AGENDA

Raymore Planning and Zoning Commission Regular Meeting
City Hall – 100 Municipal Circle
Tuesday, December 16, 2025
6:00 PM

7 BREW SITE PLAN (RAYMORE GATEWAY LOT 2)

PROJECT LOCATION	REQUESTED ACTION
NW Corner of Westage and Foxwood Drives	Site Plan Approval

DRAWING TITLE:
SITE PLAN

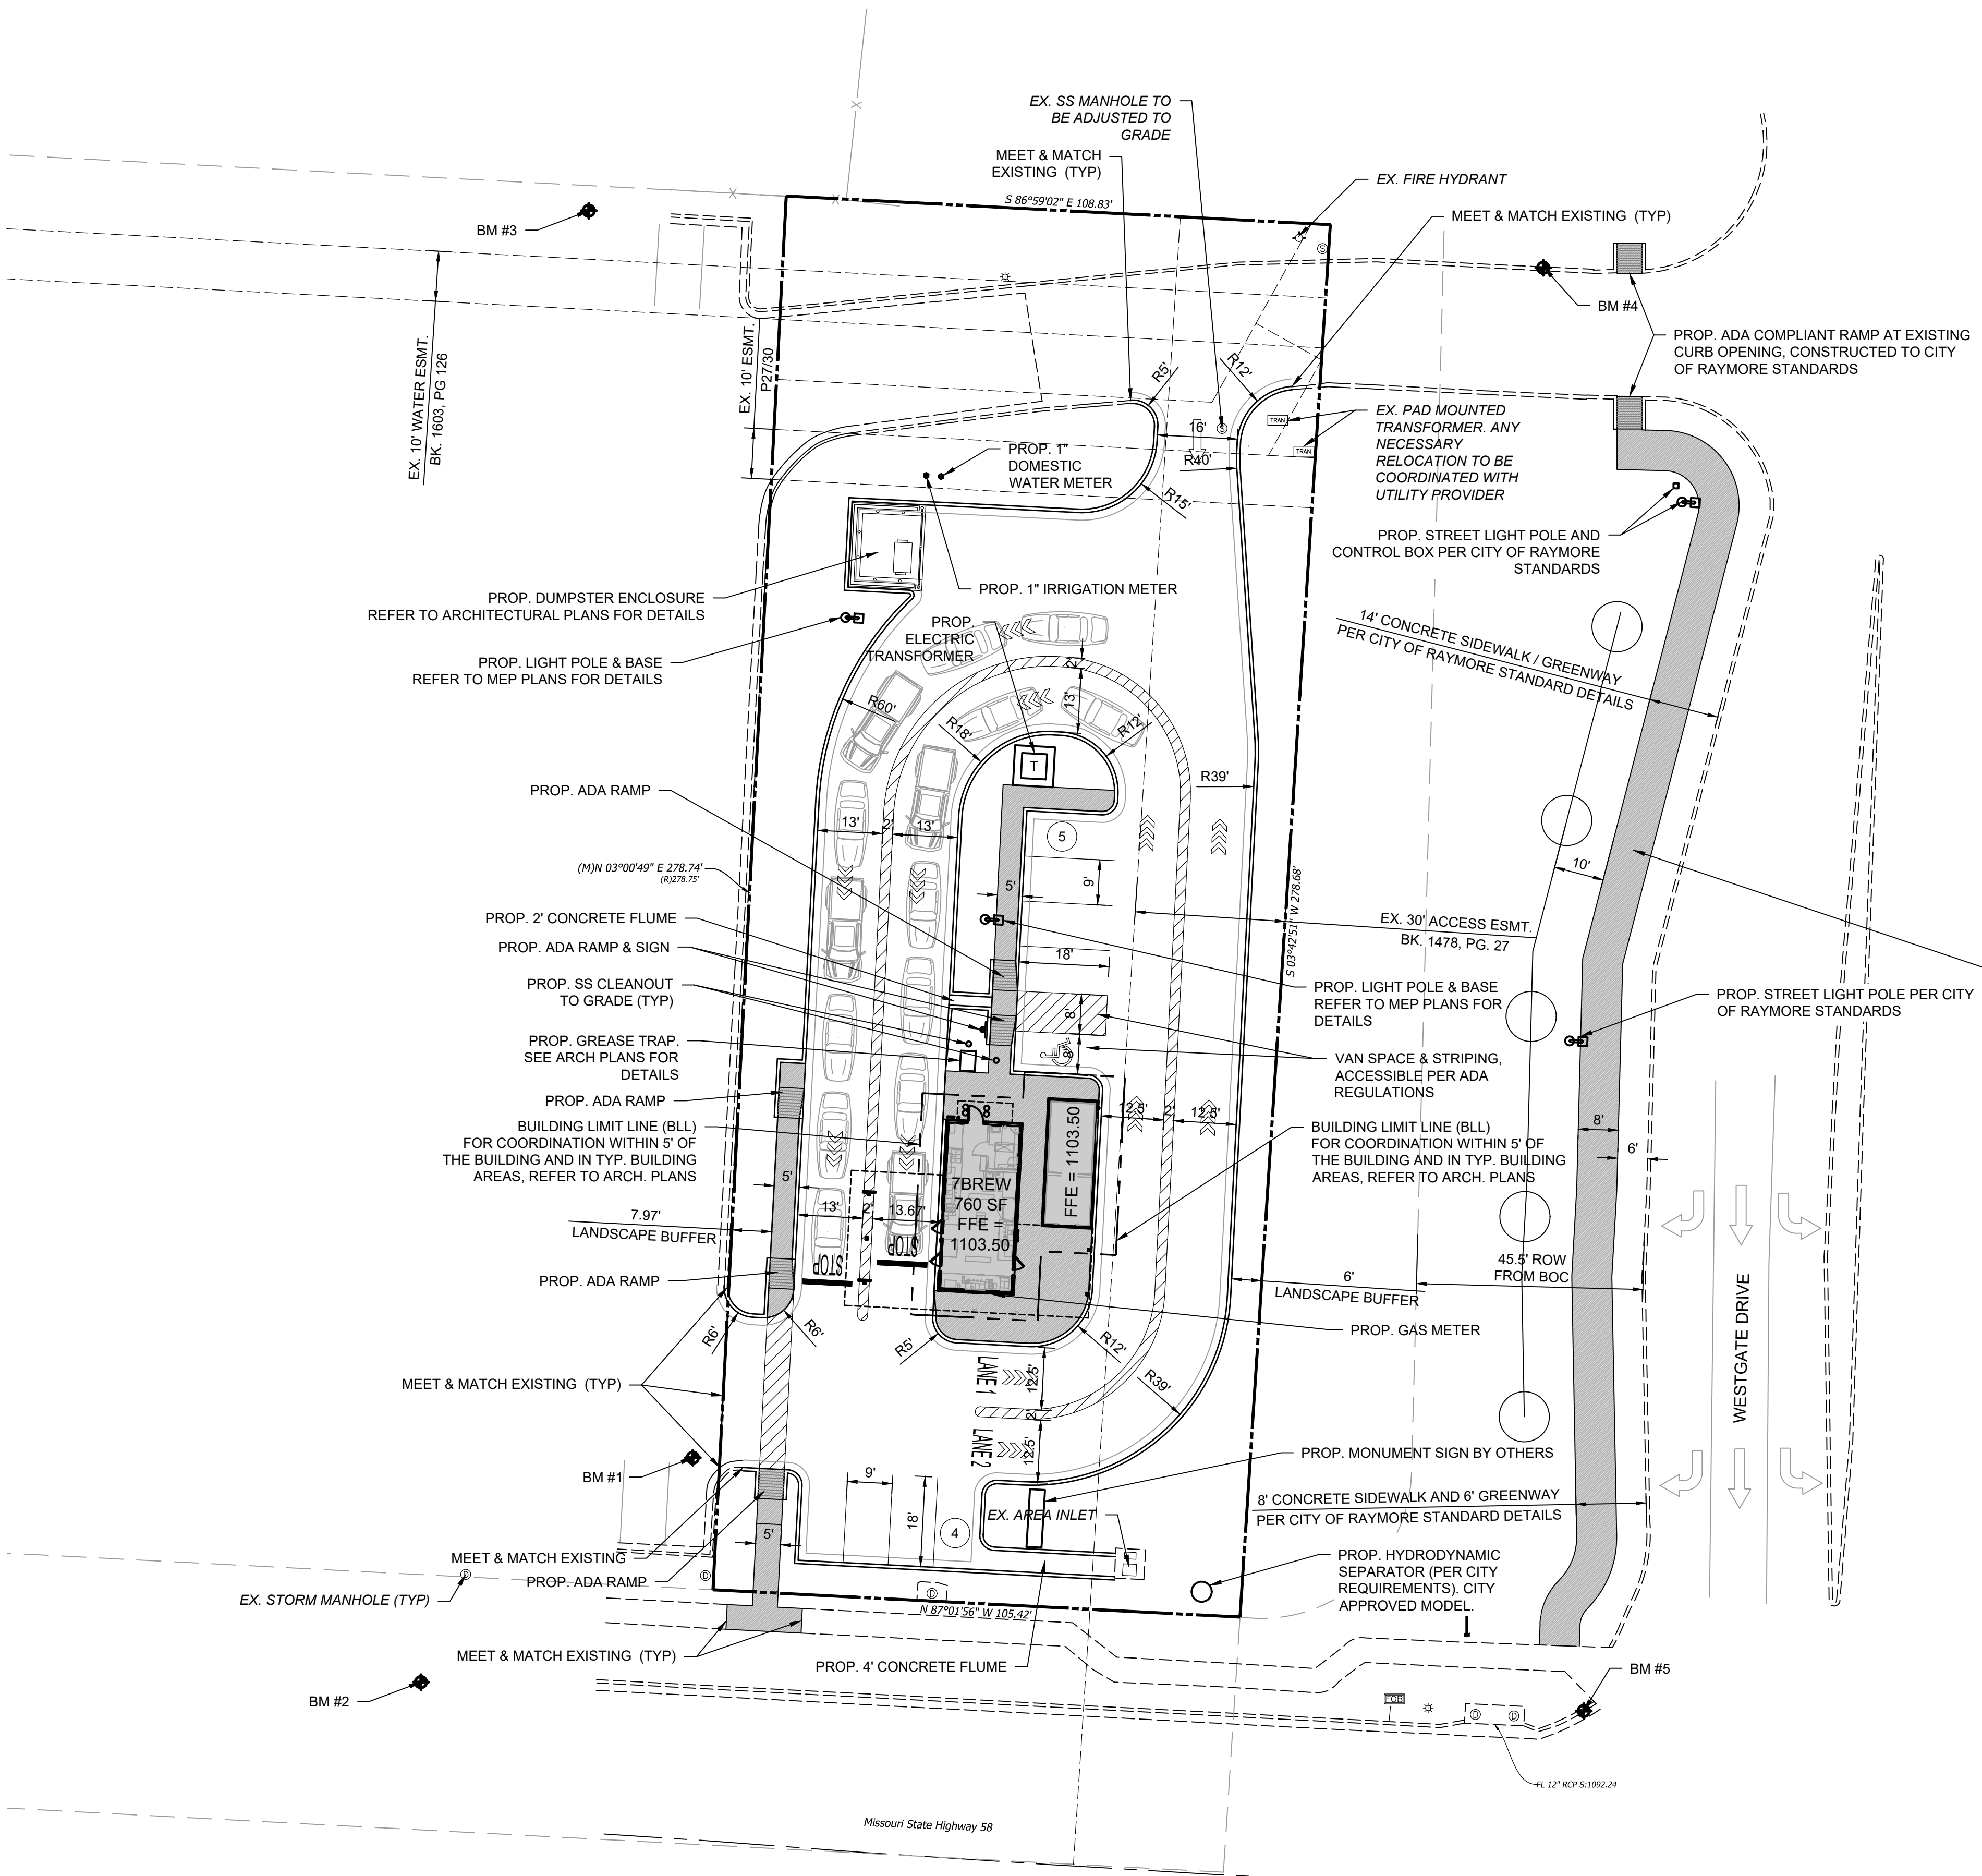
SITE CIRCULATION: Given that the property has a shared access point with the neighboring Lot 1 (Chic-fil-A), staff has requested an access easement be provided for both Lots 1-2 of Raymore Gateway to provide for shared access between properties. Currently, both lots are under common ownership, however, if either were to sell in the future to different parties, the access easement would ensure that either lot has the legal right to use the drives for their individual use. The easement would benefit Lot 2 more given its site design.

- Staff has identified concerns over the collection of auto-centric land uses, such as Drive-Through Facilities, in concentrated areas of the city. While individually they may meet the minimum development requirements, collectively, they present development patterns and infrastructure challenges that are in conflict with many of the goals outlined in the UDC and Comprehensive Plan, such as promoting balanced growth and reducing traffic congestion.

The proposed drive-through establishment adds to an already dominant land use in the immediate area. While the UDC allows the use, the growing number of such car centric businesses is becoming more prevalent in the community, specifically along Foxwood Drive. When concentrated, single use development that prioritizes vehicular movement over multi-use pedestrian scale design creates monotonous strips of commercial corridors void of interest and inspiration. The sprawl created by such land uses forms an environment where the day to day goods and services are almost only accessible by car, as walking such distances takes too much time, is uncomfortable, and in most cases puts pedestrians in unsafe environments.

The plan provides pedestrian connections to the public sidewalk system along Foxwood Drive. On the site, private sidewalks are provided near the building at the drive-through, across the parking lot areas and out to the public sidewalk. Overall the relatively small site is abundant with pedestrian circulation routes, however, many of which are crossing driveways or drive-through queuing lanes, a by-product of the type of development. The relationship between heavy drive-thru traffic and pedestrian traffic poses safety conflicts.

The development does provide an adequate amount of parking on-site for the use given the lack of needed permanent parking spaces as a result of the land use. The adjacent Lot 1 of Raymore Gateway has additional off-street parking that could be utilized if necessary. An access easement will need to be provided to allow vehicular circulation and parking across the sites if the ownership changes on either lot. The cross-access easement should be provided prior to the occupancy of the building.

1. A cross access easement shall be recorded, prior to the issuance of the Building Permit for Lot 2, to allow site circulation and parking between Lots 1 and 2 of Raymore Gateway. A copy of the recorded easement shall be provided to the city.
2. 7 Brew or any other future tenant located on Lot 2 shall restrict the flow of traffic at the north driveway access at peak times. If problems with traffic occur due to the north driveway not being managed, that driveway may be removed at the cost of the property owner.
